August 14, 1984
JPN-84-54

Subject: James A. FitzPatrick Nuclear Power Plant
Docket No. 50-333
Mark I Program

Response to Open Items from NRC/BNL/NYPA/TES Meeting

June 13, 1984

T-QUENCHER LOCATIONS - FITZPATRICK

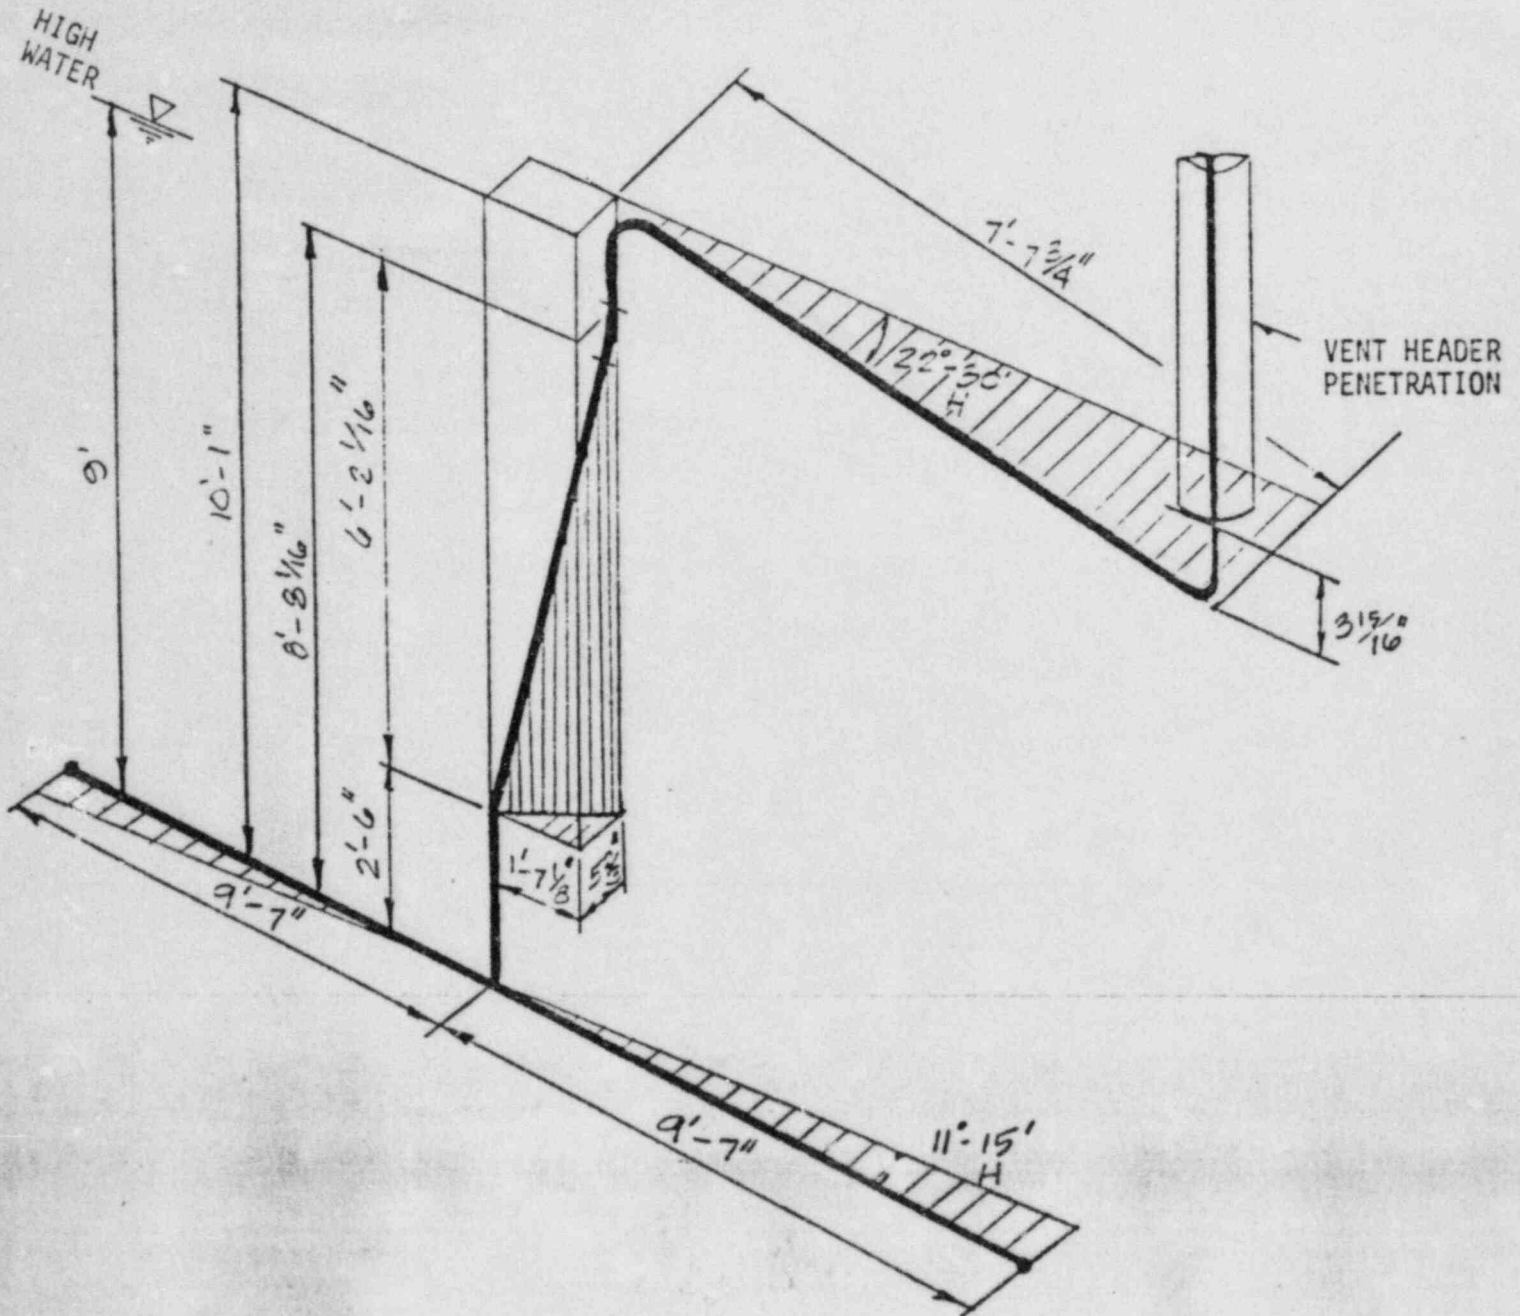
Item 1 Identify SRV lines which provide the ADS function

Response There are seven ADS lines at FitzPatrick. These are lines A, B, C, D, E, G, H. They are shown on the attached sketch.

TYPICAL FITZPATRICK SRV LINE ROUTING IN POOL

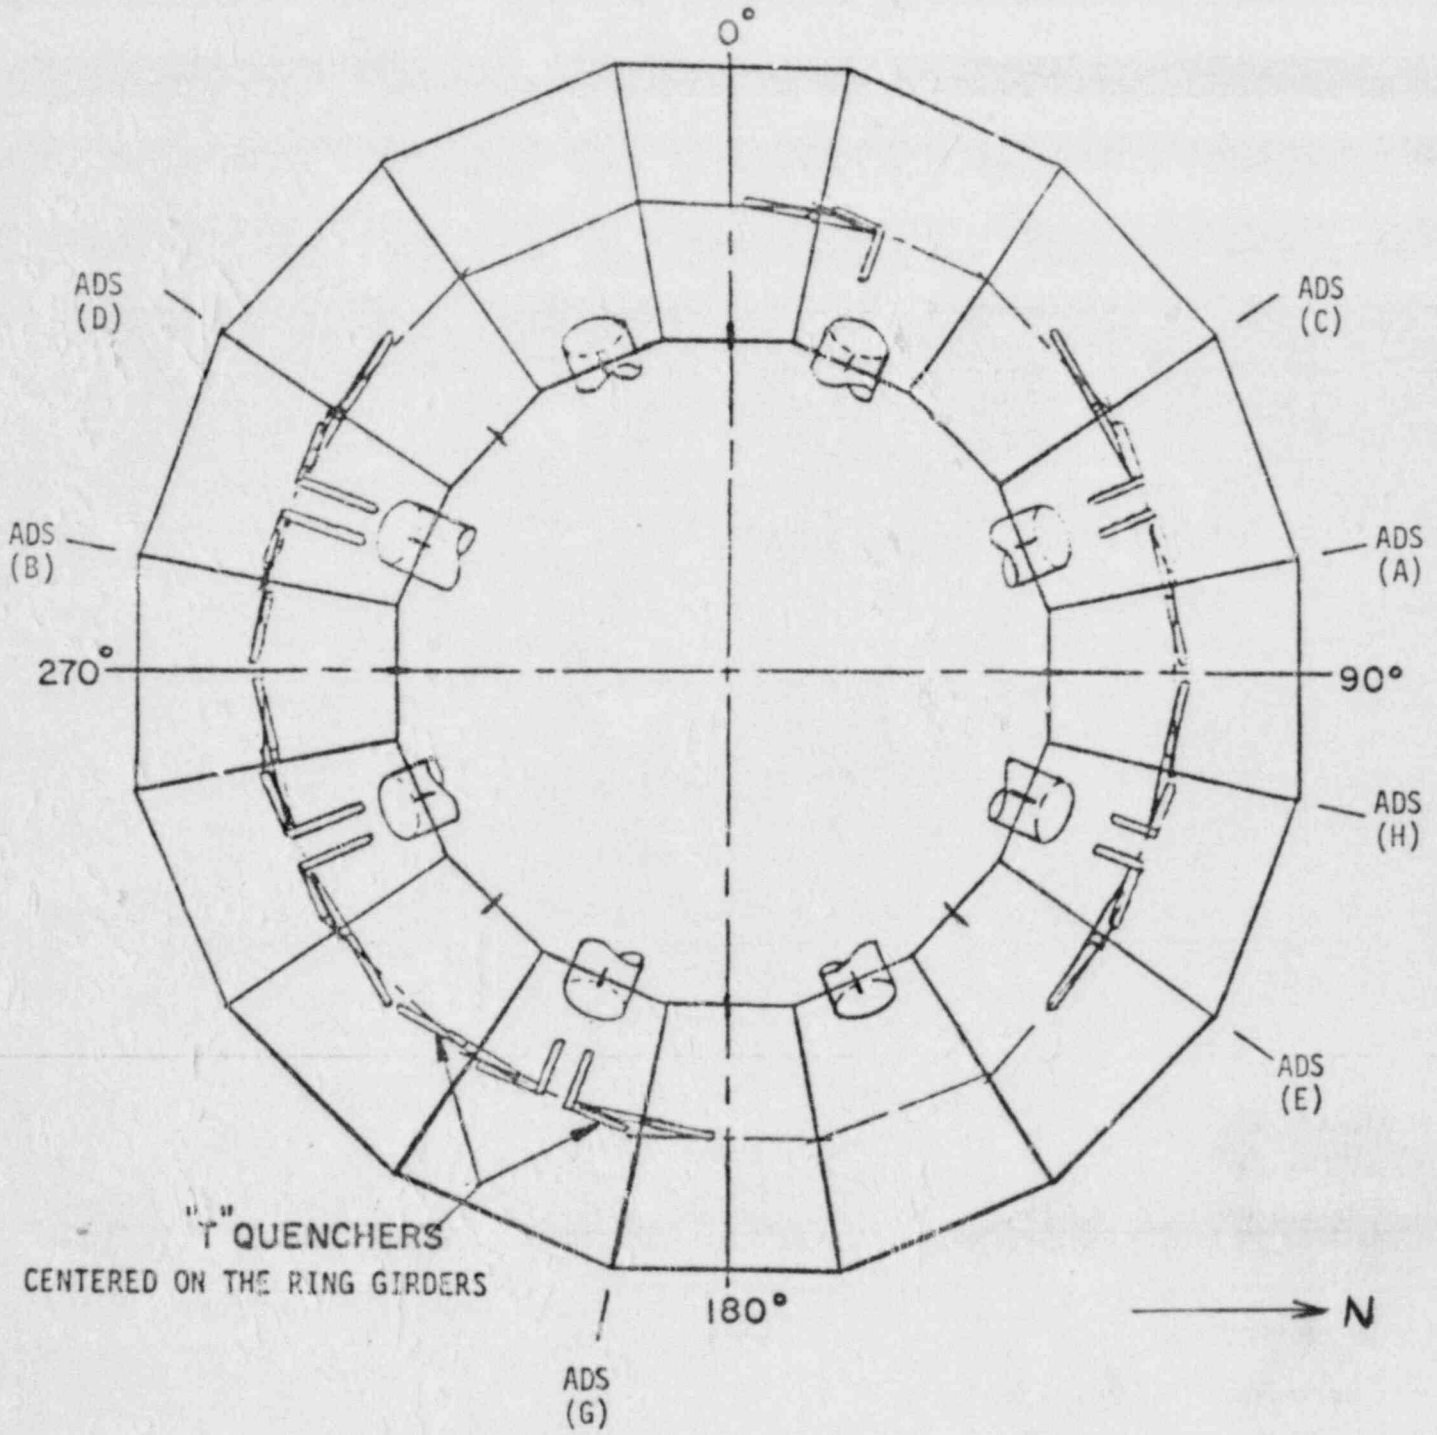
Item 3 Provide a corrected figure showing SRV line entry angle into the pool (part of presentation to Item D-3)

Response The corrected figure is attached. The figure included in the handout had an error in location of one dimension.

This figure was included only to show entry angle and did not effect any other part of the presentation.
